**To:** Larry Hudgens; Utilities Office Staff  
**Cc:** Brett Taylor; Norm Collins; Gary J. Van Riessen  
**Subject:** RE: Big Creek Interceptor UPRR Folder 3287-12

Thank you for your work plan submittal, [this work plan is released for construction as noted](#). Please continue working with Marianne or Tyler regarding other onsite observation and flagging requirements:

Big Creek Interceptor / Union Pacific Rail Road  
Railroad bore 164 LF / 42" steel casing with 30" PVC carrier pipe.  
Bore pit east of Railroad Right of Way / 24 VF.  
Excavation will be cut down to below 20 VF using a series of trench boxes.  
Receiving pit; west side of abandoned track / 55 LF.  
Trench excavation 10 VF using manhole trench box for shoring.  
(See attached plan sheet)

SHEET C1	<b>SANITARY PLAN AND PROFILE</b> STATION 10+00 TO 22+00	REVISIONS	
	BIG CREEK INTERCEPTOR SEWER UPSIZING LEE'S SUMMIT MIDDLE SCHOOL #4	2021	REVISIONS DESCRIPTION 1 8-25-2021 ASI #29 - REVISED PER CITY COMMENTS
LEE'S SUMMIT, MO	2021	BY	FINAL DESIGN NOT FOR CONSTRUCTION

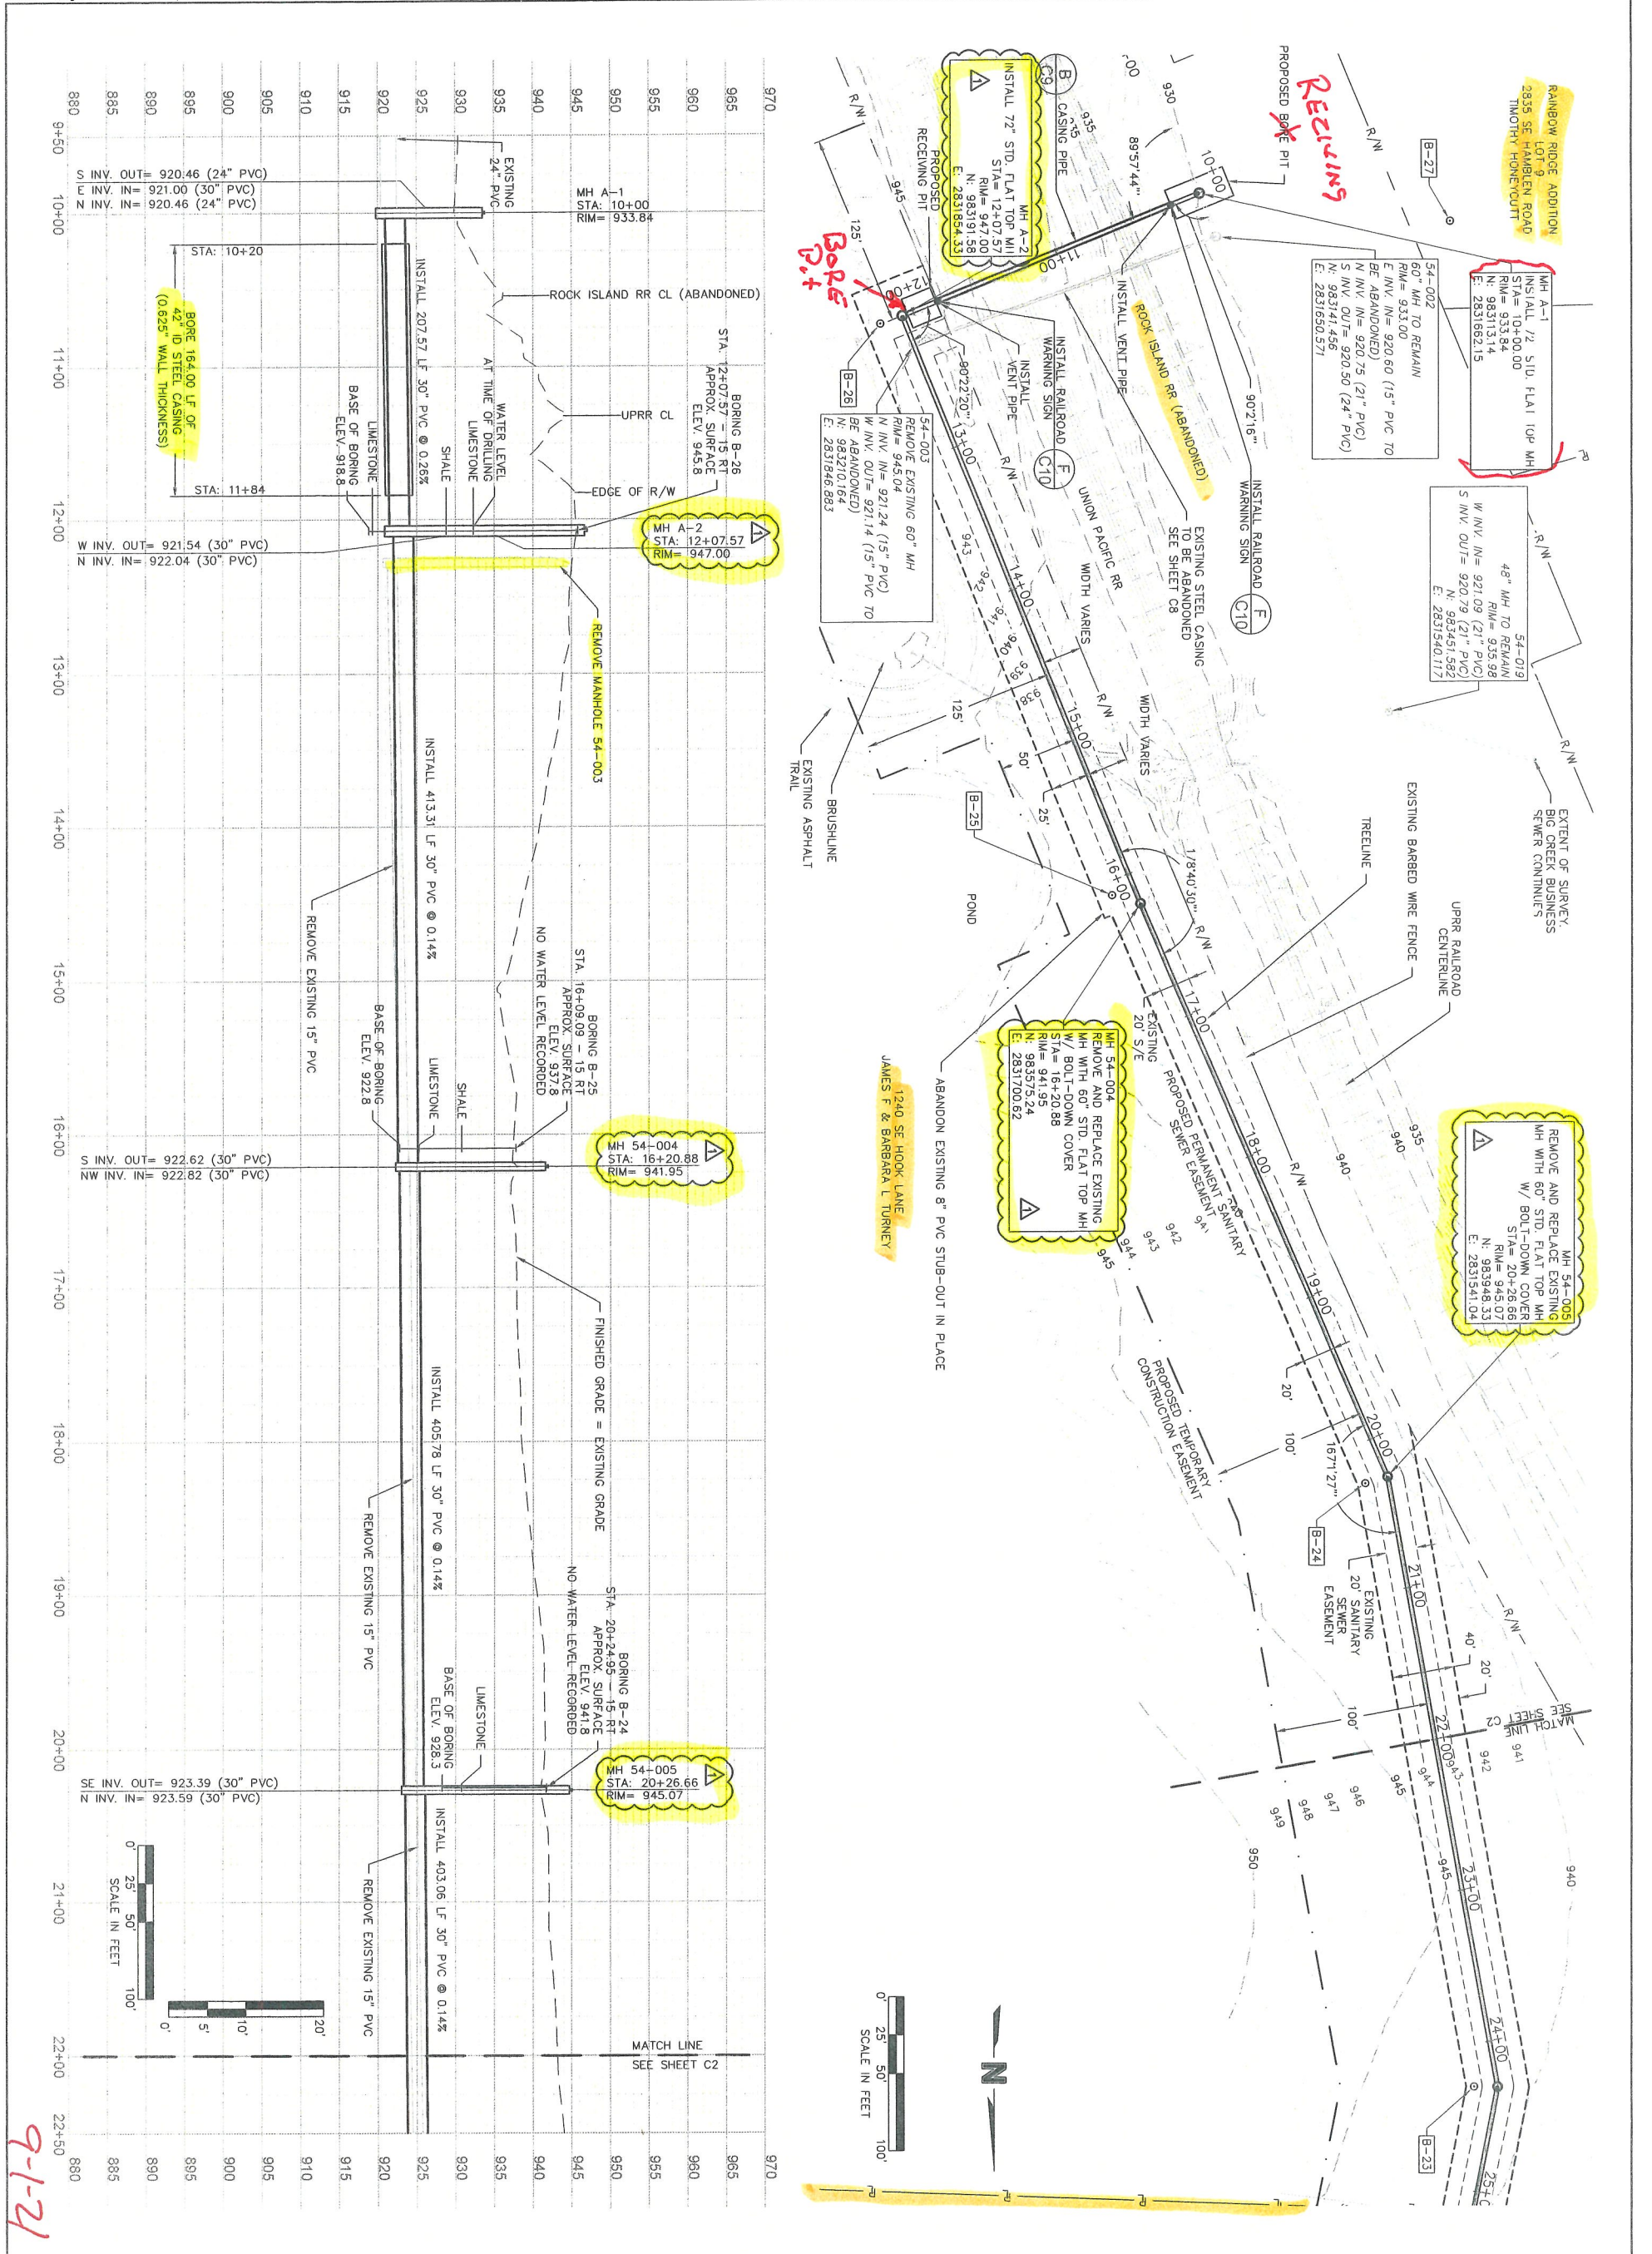
Mr. Doan, I have attached updated Work Plan along with plan sheets C-1 & C-8 for your review and approval . I still need to provide you some additional information regarding track monitoring survey from Olsson associates .
